SUBJECT: Arkansas Nuclear One, Unit 2
Docket No. 50-368
License No. NPF-6
Supplemental Response to the Bare Metal Visual Relaxation Request for
ANO-2 Regarding NRC Order EA-03-009

**Supplemental Response to the Bare Metal Visual Relaxation Request for ANO-2
Regarding NRC Order EA-03-009**

Figure 1

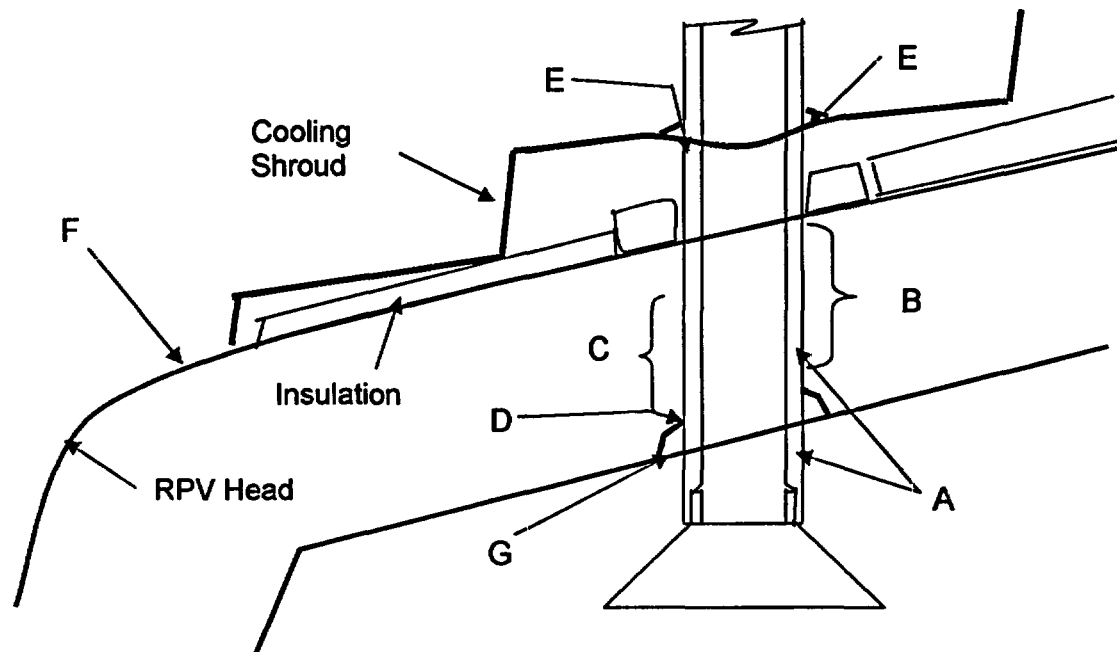
Pertaining to the overall approach address how an acceptable level of quality and safety is met, if the proposed approach represents a reduction from the level that would be provided by BMV (why is this okay?).

The overall approach for ensuring that an acceptable level of quality and safety is being met is provided by the comprehensive examinations of the ANO-2 RPV head in the fall 2003 refueling outage as discussed below. The basis for this conclusion is provided in the subsequent portion of this response by showing compliance to the Order and not having a significant reduction in the level of quality and safety from the proposed inspection regime.

Comprehensive Approach to ANO-2 Reactor Head Inspection - The unique "stair-step" shroud configuration at ANO-2, as discussed in Reference 2, creates a hardship in performing the BMV examination to meet the requirements of NRC Order EA-03-009. Because of this hardship, Entergy has worked closely with Westinghouse to develop new examination approaches, as well as improvements to some of the traditional inspection techniques in order to provide an overall RPV head inspection approach that provides an acceptable level of quality and safety. The ANO-2 reactor head inspection approach that is being applied in lieu of a BMV inspection for the fall 2003 refueling outage is a comprehensive methodology. This inspection regimen is designed to provide defense in depth for detection capability of any PWSCC flaw that could develop in the J-groove weld or penetration nozzle. This comprehensive approach combines the use of several diverse and complementary inspection techniques. These techniques culminate to provide a complete examination and inspection of the RPV head which provides an appropriate level of quality and safety. This complementary inspection approach is best illustrated by the following sketch (Figure 1) which demonstrates how each examination and inspection technique covers the entire length of the penetration to ensure that PWSCC indications are found in the nozzle or J-groove weld, penetration leakage is detected, and that the RPV head integrity is maintained.

Primary Examinations

- A = Volumetric Examination of CEDM/ICI penetration tubes utilizing MRP demonstrated UT techniques.** This ensures that the critical length of the nozzle is free of defects and potential leakage paths.

- B = Low Frequency Eddy Current Examination of the portion of the CEDM and vent line penetrations that are above the J-groove weld.** This examination will interrogate the area between the penetration tube and the reactor head looking for degradation of the carbon steel head material.

- C = Penetration Annulus Leakage Assessment using Westinghouse demonstrated zero degree UT technique.** This ensures that the leak path from a leaking nozzle or weld will be detected and qualitatively determined to have a loss of interference fit through the annulus which can also be detected by LF ECT. This examination can detect leakage through the J-groove weld or through the buttering, if it were to occur.

- D = Triple-Point Examination utilizing Entergy/Westinghouse developed and EPRI/MRP demonstrated UT technique.** This process provides the unique capability to further investigate 0.060" into the J-groove weld and determine the integrity of the penetration weld and to support the conclusion that boric acid deposits will not be present on the RPV head.

- E = Supplemental Visual Inspection performed from above the cooling shroud plate, which has the capability of detecting boric acid that has either descended onto the head from**

above, or has migrated upward from the head and may be visible at the top of the reactor head insulation.

F = Bare Metal Visual Inspection of the accessible portions of the RPV head, including the flange area, part of the lower dome, and around the annulus of the ICI nozzles. This examination is performed to detect corrosion that may have occurred in the accessible areas, to detect leakage around the ICI nozzles, and to look for evidence of boric acid residue that may have run down the head from a leaking penetration.

Conditional Examination

G = Surface Examination of J-Groove Weld utilizing liquid penetrant or eddy current. This is a contingency examination that would be utilized to further investigate a positive indication of a potential PWSCC flaw found with any of the primary examination techniques.
